TOWN OF COVENTRY, RI
DEPARTMENT OF PLANNING & DEVELOPMENT

STAFF REPORT

Project Name:	Picozzi Plat
Plan Type:	Minor Subdivision
Plan Review Phase:	Pre-Application
Owner/Applicant:	Domenico A. Picozzi
Address:	0 Read School House Road
Plat / Lot / Zone:	AP 89 Lot 9 Zone RR-2 Lot Size 8.24 acres
Existing Use:	Vacant
Proposed Use:	4 single-family houses
Description:	The applicant proposes to develop one commercial office building and two equipment storage buildings for contractor use, with development occurring in phases.

TECHNICAL REVIEW COMMITTEE REPORT

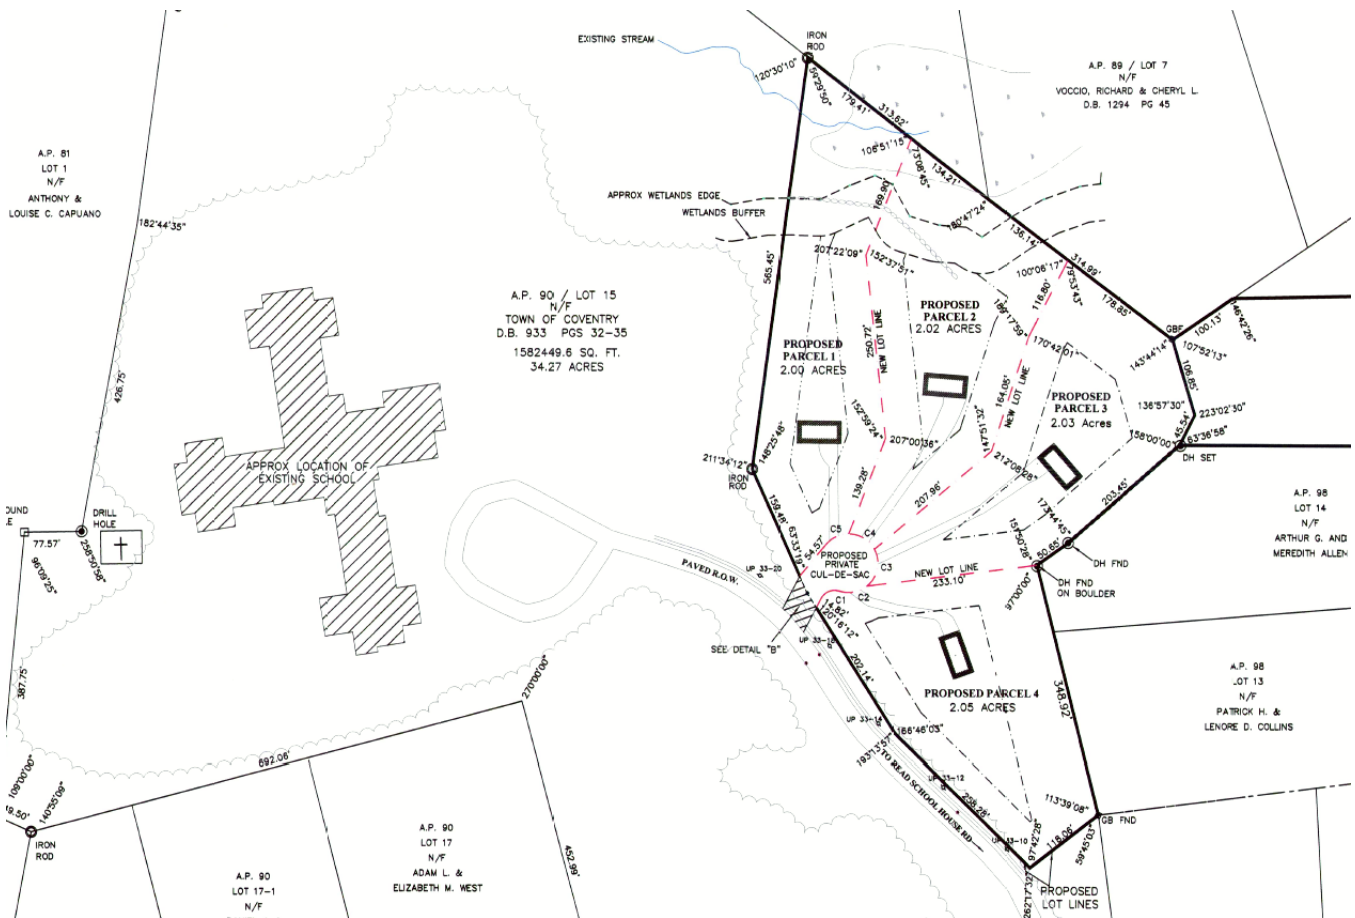
As submitted, the proposal would subdivide the subject parcel into four single-family house lots (as delineated by the dashed red lines in the site plan excerpt above). Proposed Parcel 1 would be exactly 2.00 acres, Proposed Parcel 2 would be 2.02 acres, Proposed Parcel 3 would be 2.03 acres, and Proposed Parcel 4 would be 2.05 acres.

Access to the proposed houses would be provided via a proposed private cul-de-sac off the existing driveway to the school; such access will be assured with a formalized easement. The applicant has also delineated the approximate edge of the wetlands as well as the wetlands buffer at which point the lot lines for the proposed subdivision will end.

- N Dimensions of the Cul-de-sac are not included in the site plan. A 50' radius will allow fire apparatus access.
- Fire apparatus access requirements from the Cul-de-sac to the dwelling shall be met.

- Additional Street lighting in the Cul-de-sac.
- Distance from the fire hydrant at the corner of Read School House Rd. and the school access road exceeds the requirements. Although there is a fire hydrant in the parking lot of the school, that one is for the parking lot and school protection and even if available would require fire apparatus to drive past the proposed subdivision entrance to secure a water source. Attempting to use that hydrant during school hours may prove to be inefficient and/or unsafe.

- A new hydrant could be added at the entrance of the cul-de-sac on the left side.
- Water flow availability for the hydrant to cover the additional structures would need to be confirmed as additional water flow may be above the school's requirements.
